Accessibility Report

20-22 Atchison St
St Leonards, NSW

Report No: 25056-201-R01 Access Report
Revision: 02
Date: 22 September 2025

Drawing Title: **BASEMENT 5**

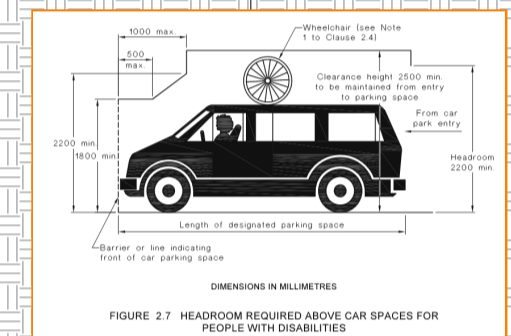
General comment relating to all adaptable / accessible carparking spaces
 Minimum 2200mm head height clearance is required to be achieved above the dedicated space and adjacent shared area. Refer adjacent figure for areas where reduced height is permitted.
 Minimum 2200mm is required in the vehicle entries / exits and aisles.
 Ensure services do not encroach into this clear height requirement.

Drawing Title: **BASEMENT 1**

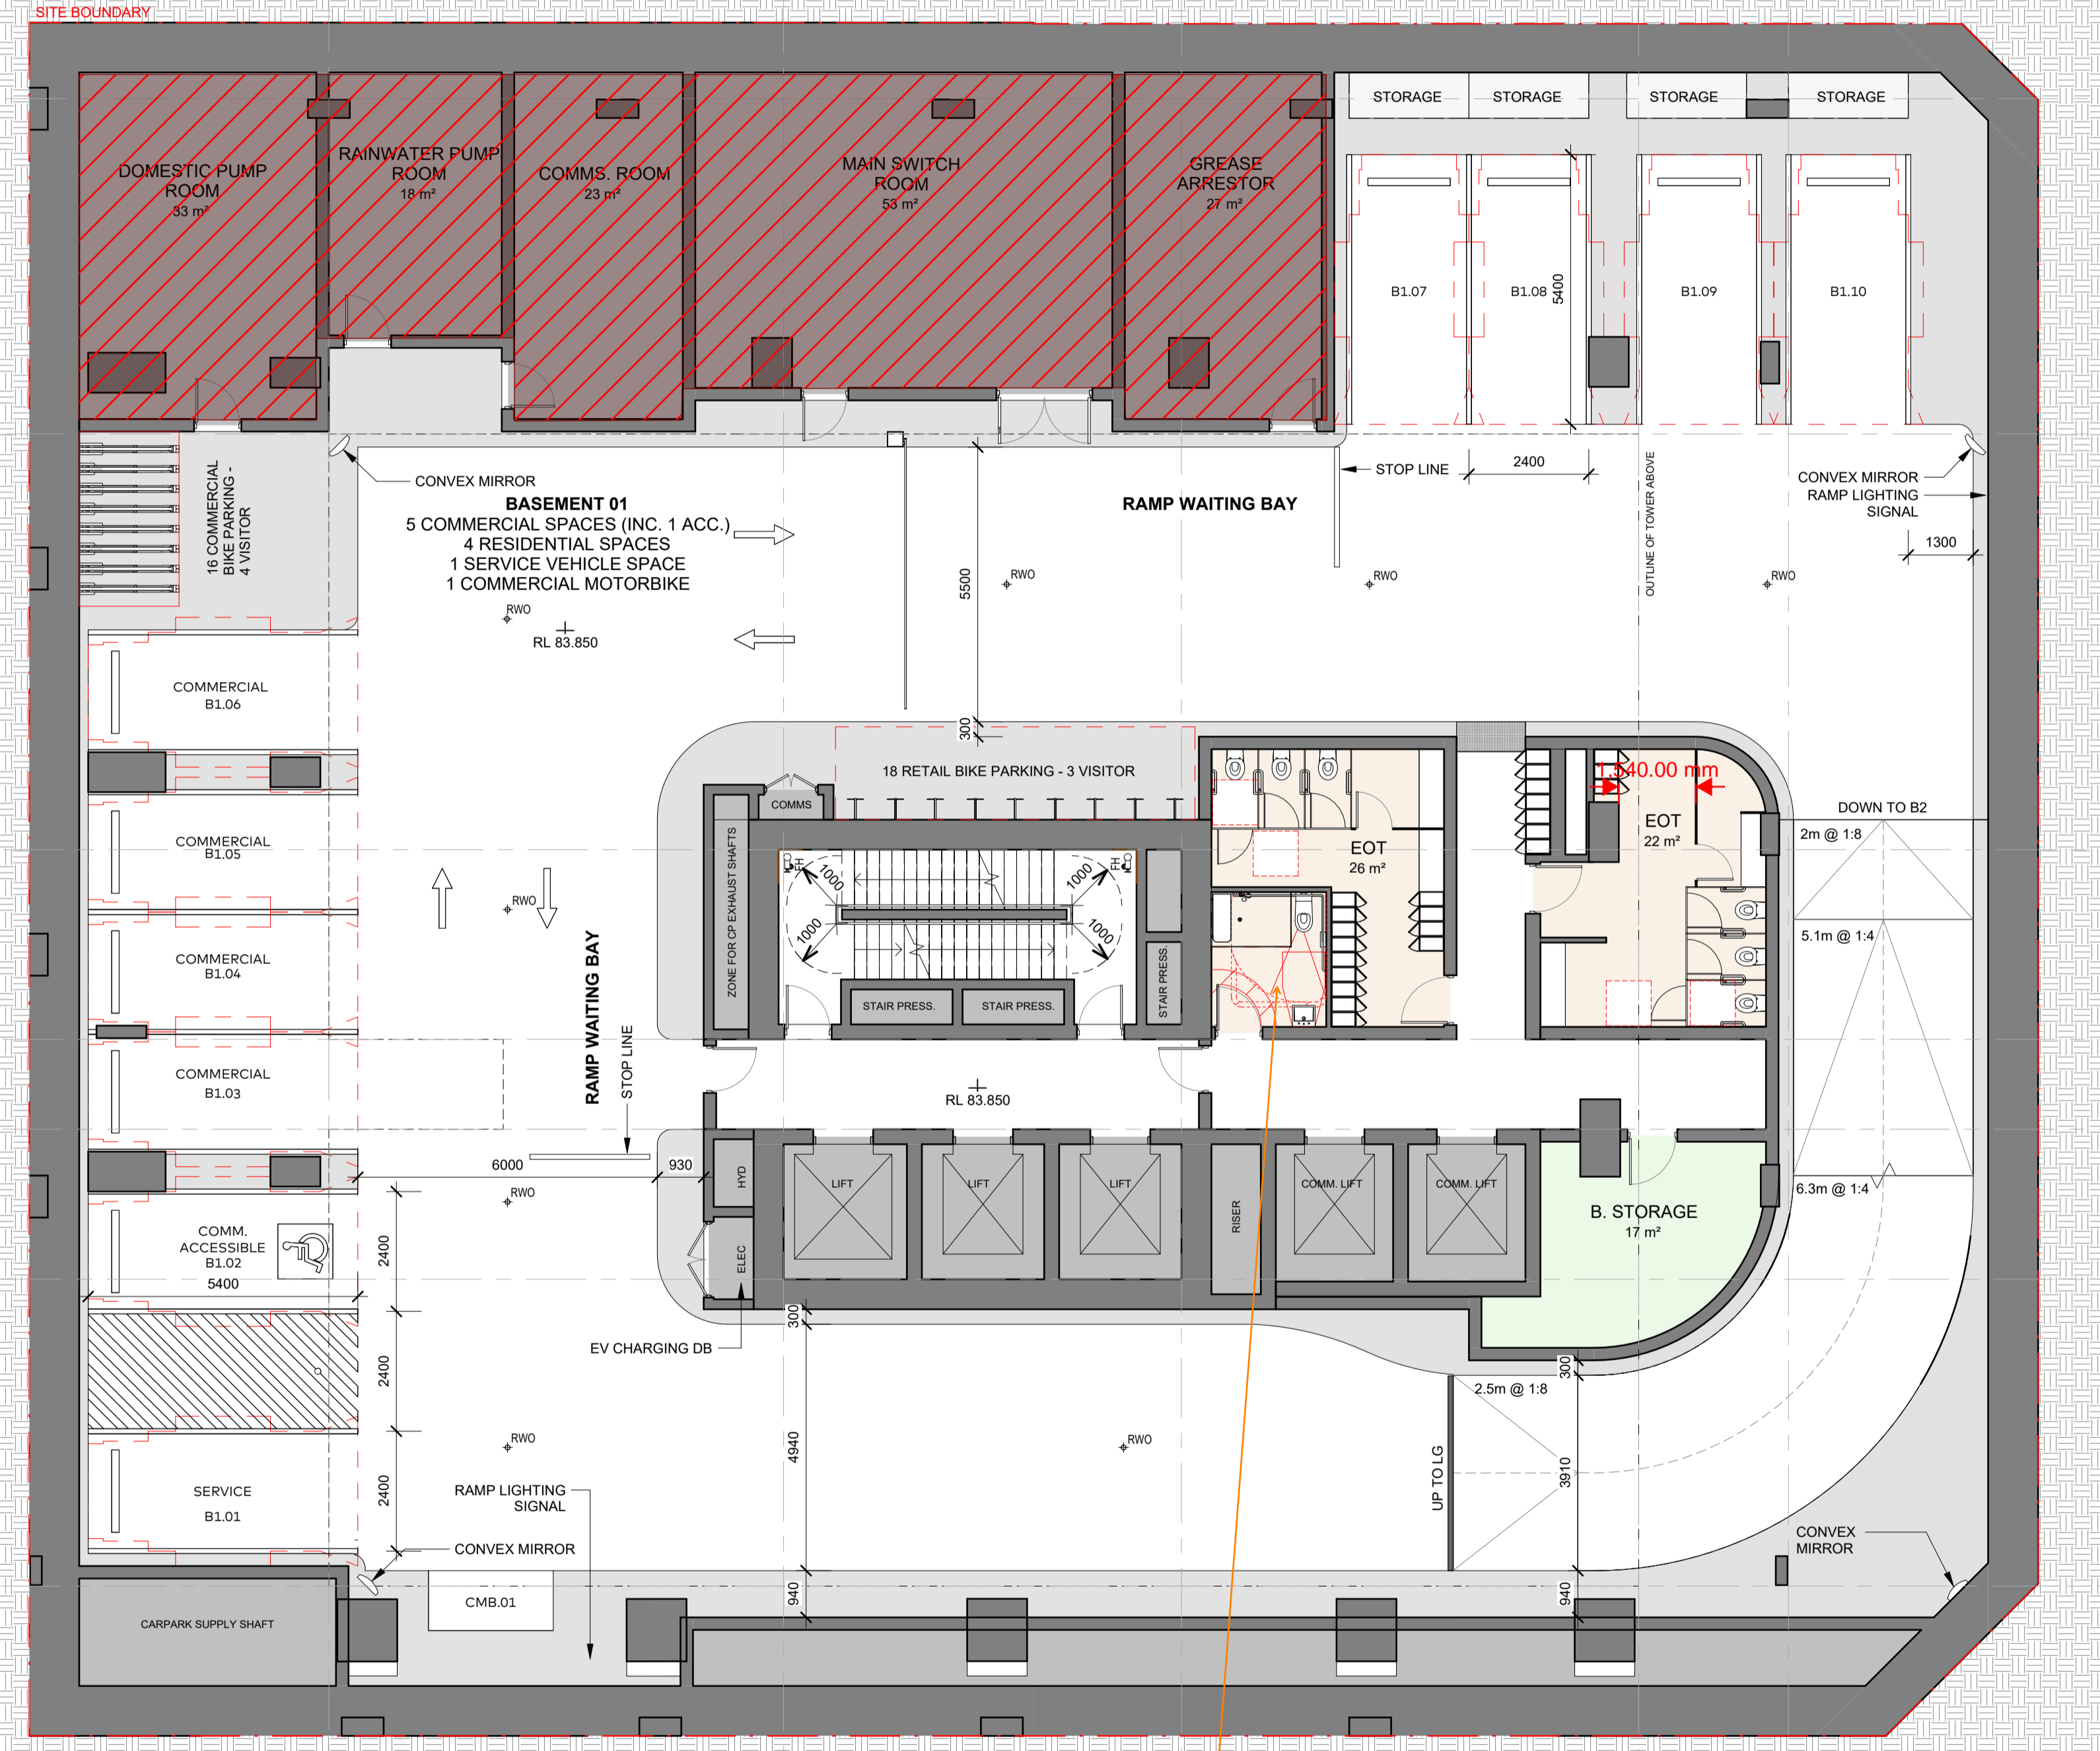
An even number of RH and LH facilities are required in the building. Currently there are 3 LH and 1 RH facility. Considering converting either this facility or the Level 4 facility to a RH facility.

Drawing Title: **LOWER GROUND**

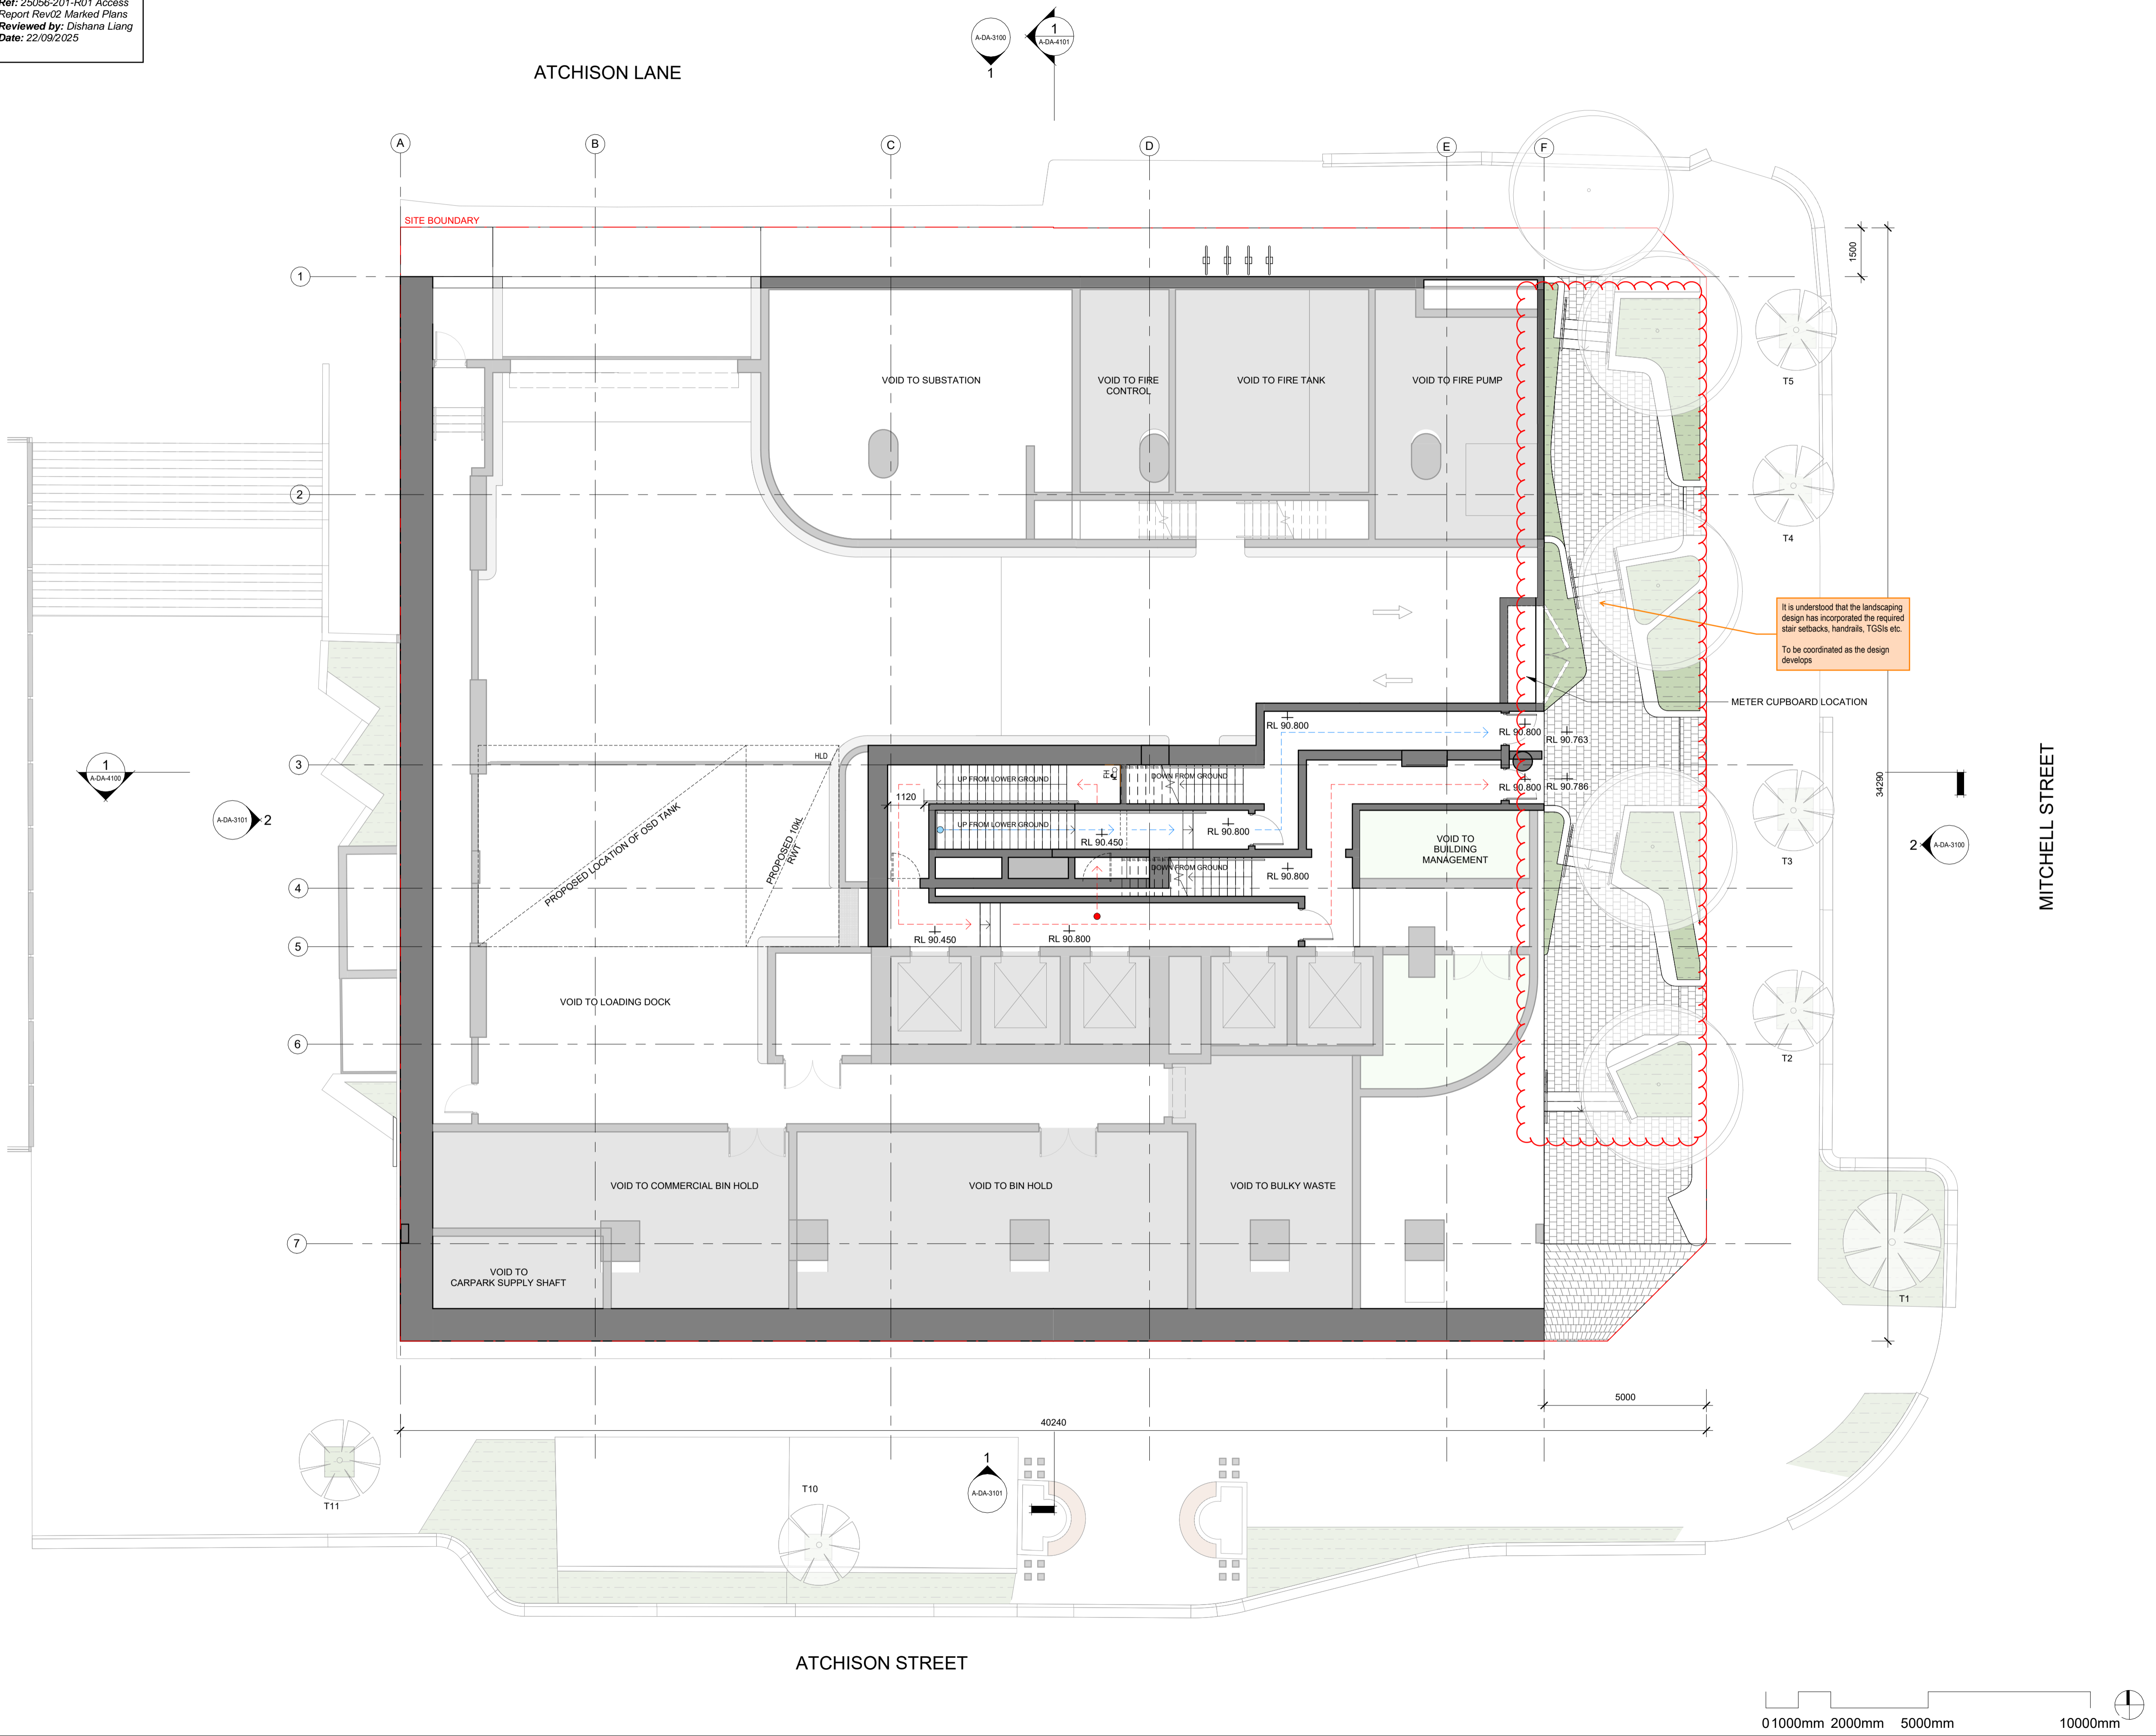
It is understood that the landscaping design has incorporated the required stair setbacks, handrails, TGSs etc. To be coordinated as the design develops

Drawing Title: **ADAPTABLE & LIVEABLE SILVER UNITS - SHEET 1**

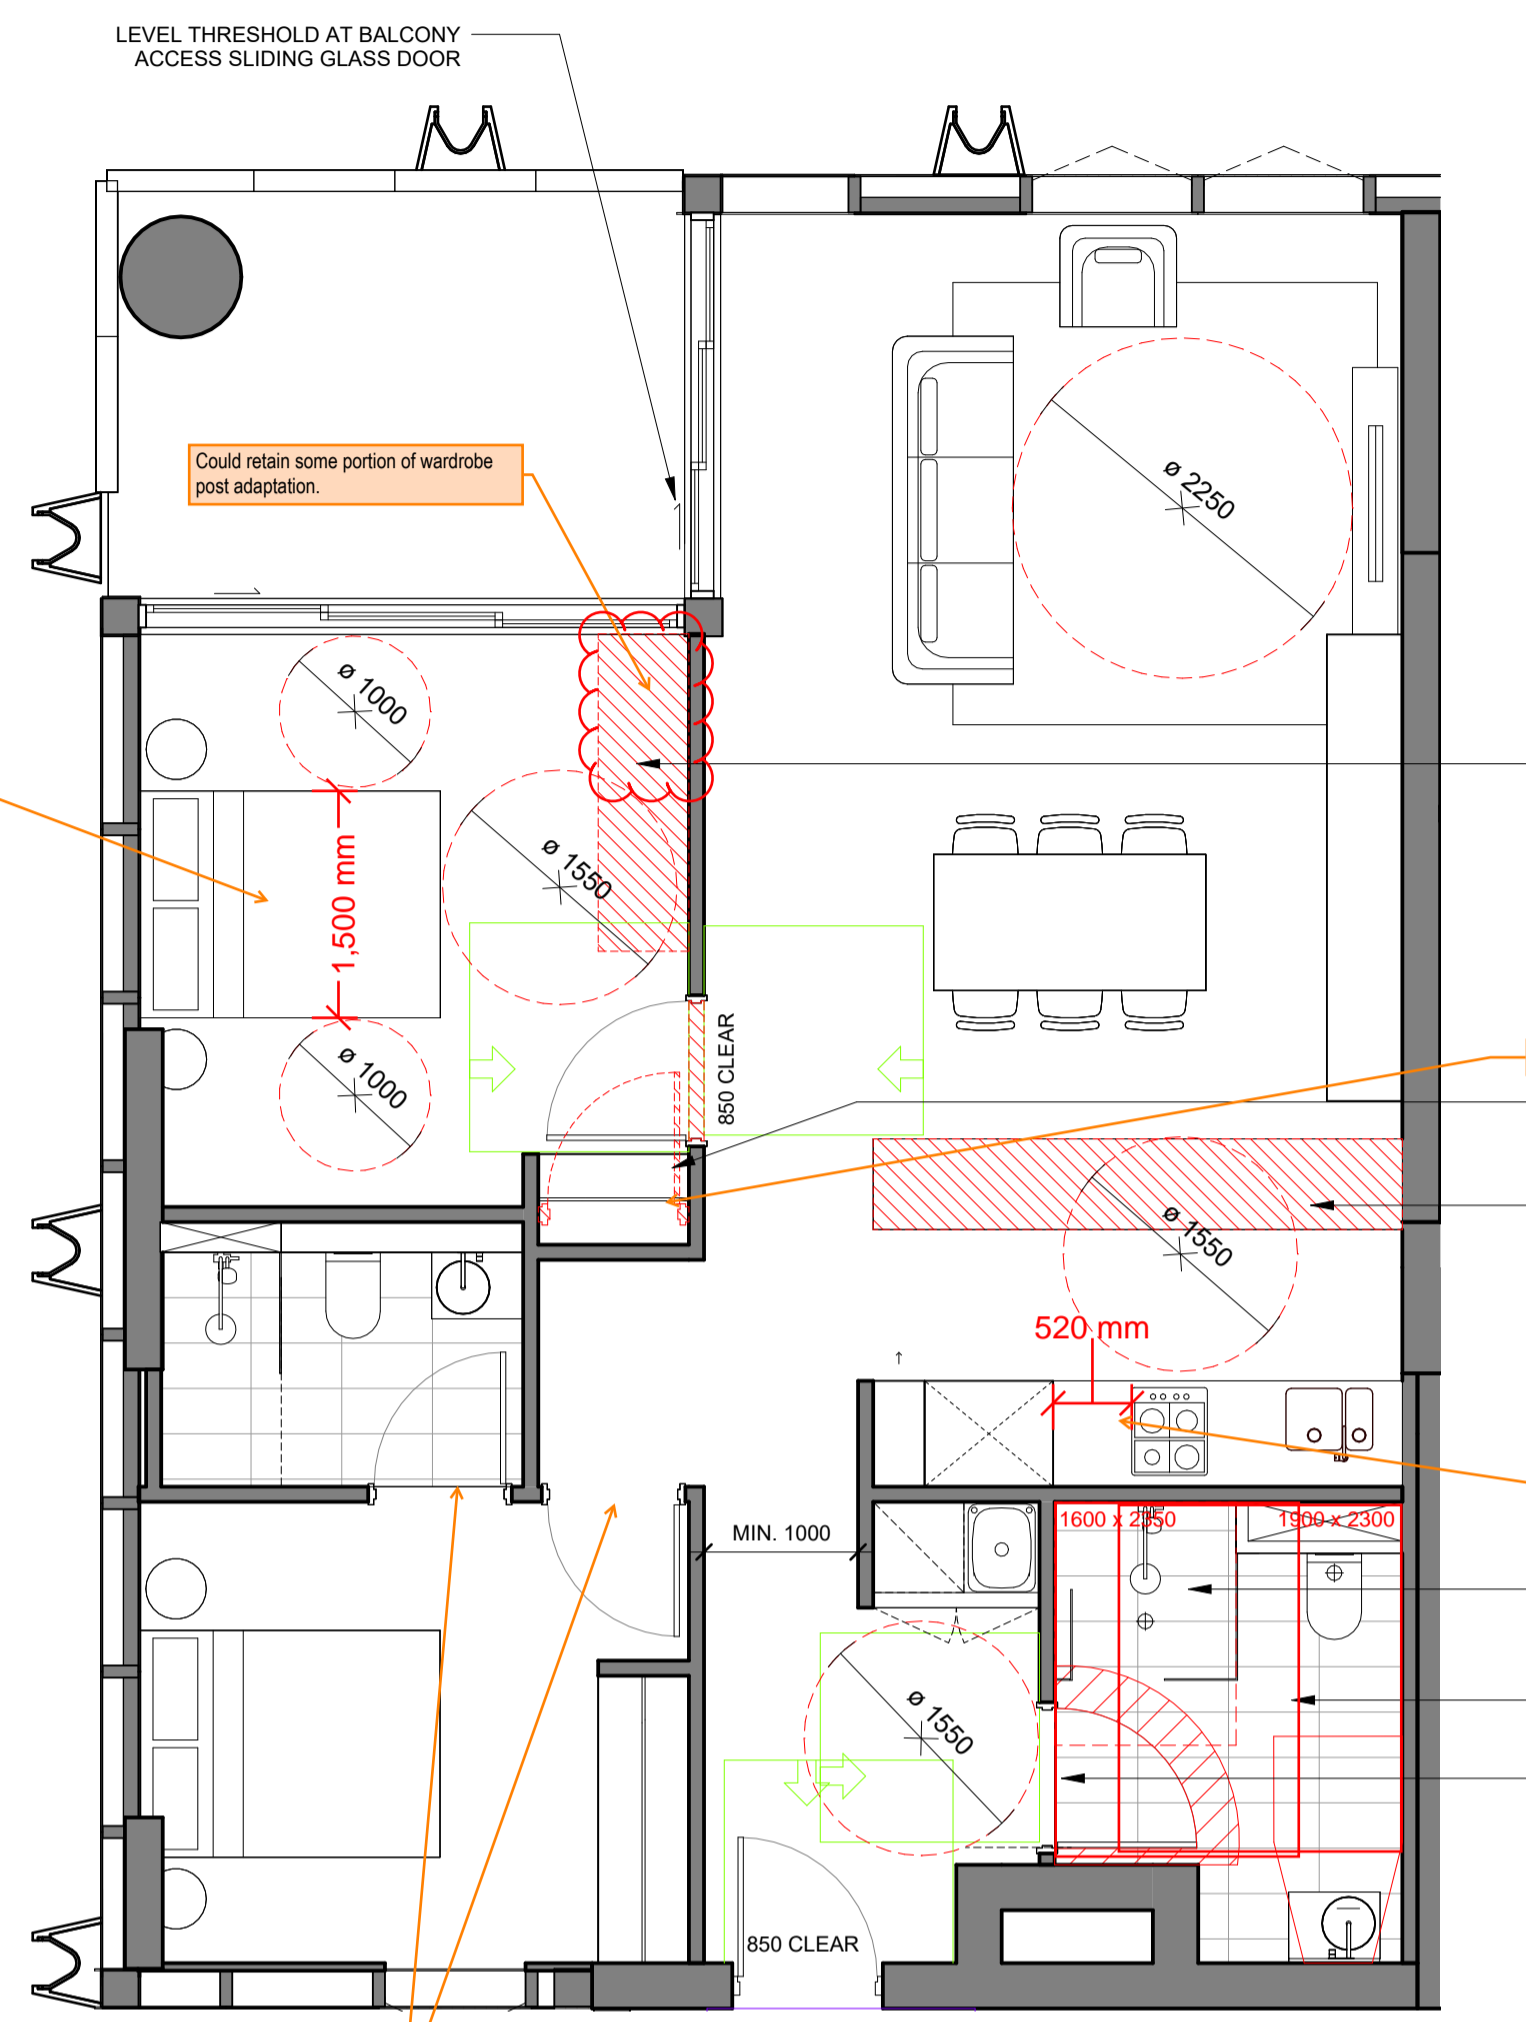
Pre and post adaptation plans required.
